**POLICY REPORT
DEVELOPMENT AND BUILDING**

TO: Vancouver City Council
FROM: General Manager of Planning, Urban Design and Sustainability
SUBJECT: CD-1 Rezoning: 4118-4138 Cambie Street

Figure 2: Site Plan

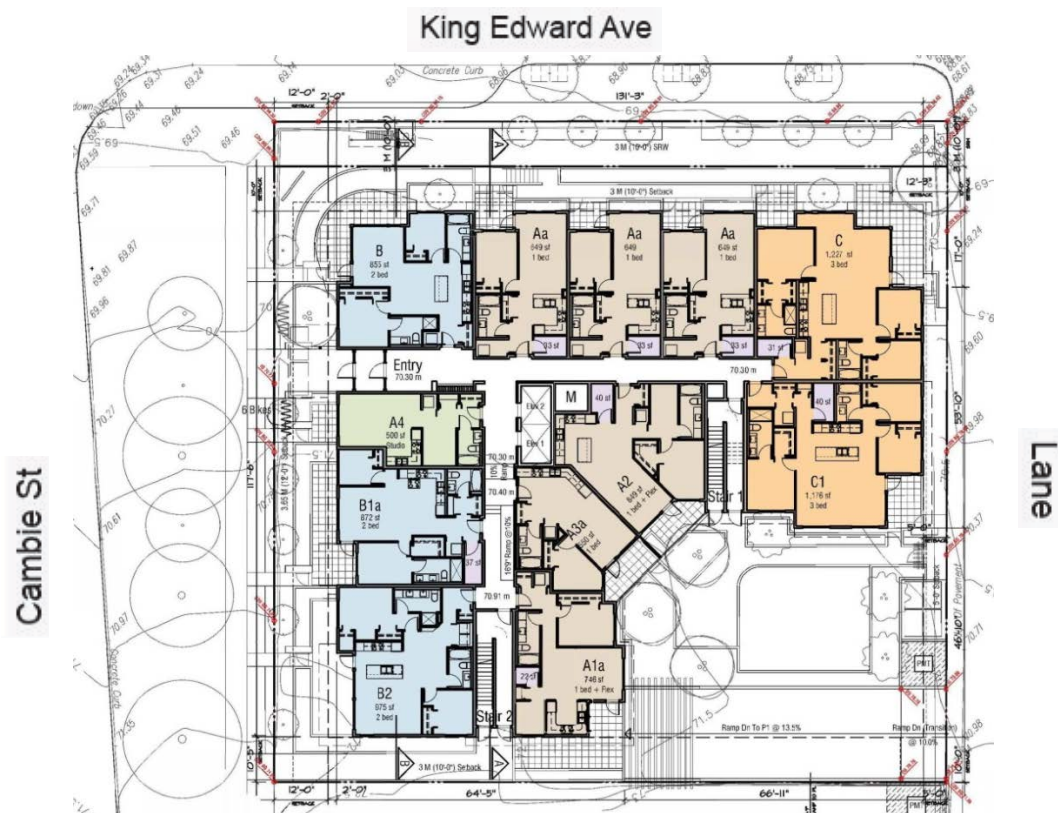
1. Design development to improve the public realm interface as follows:
 - (a) Delete the patio stairs that run parallel to King Edward Ave and the lane and replace with a continuous, soft landscaped border.
 - (b) Provide natural stone facing for retaining walls at the site edges.

2. Design development to improve northeast corner of the site and further denote the lane entry with the addition of a substantially larger planting area, including a larger tree on grade.

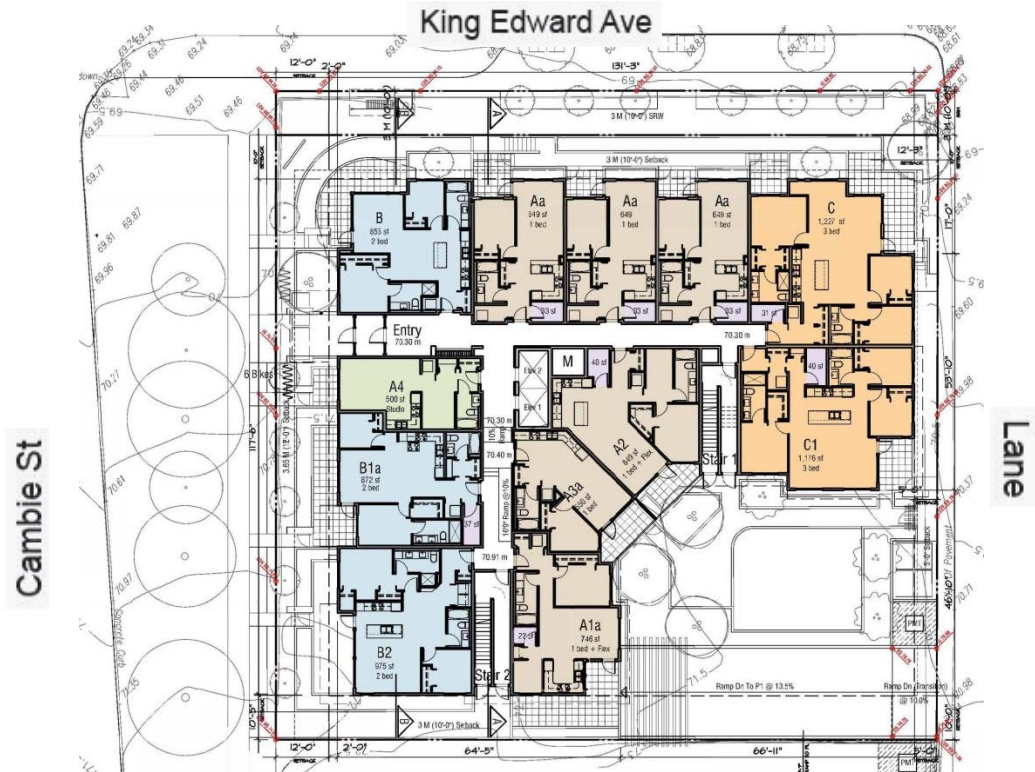
Related Commentary: The panel was supportive of the height, form and density. The building was seen to be compliant with the guidelines of the Cambie Corridor Plan. Some panel members supported the corner balcony treatment. Some did not, noting this important intersection and entry to the city should have a stronger corner.

There was discussion regarding materiality and it was noted that maintenance of white concrete may be a potential issue. The rear and side elevations should be of a higher quality in keeping with the street elevations and provide more brick, not fibre-cement.

The back garden and the relationship of the massing to the lane were noted as a positive. The knock out panel for the ramp was appreciated as it allows for a more functional rear yard amenity. The pad mounted transformer may need relocation to allow more sunlight access to the rear yard, noting it is occupying the sunniest part of the yard. It was suggested to consider a rooftop amenity with unlimited solar access, and to provide a washroom area.

It was noted that there will be significant pedestrian traffic in this location and the site edge on at King Edward is too harsh and needs further design development. The retaining walls are too high in the current proposal, noting guardrails will create additional height to 8 ft. The site edges need more interaction with the street. The granite from the existing retaining wall may be repurposed instead of concrete retaining walls. The lobby might be too undersized for social interaction and needs improved visual access from the street. The lane and sidewalk could use more benches and shrubbery.

Applicant's Response: The applicant team thanked the staff for the comments.
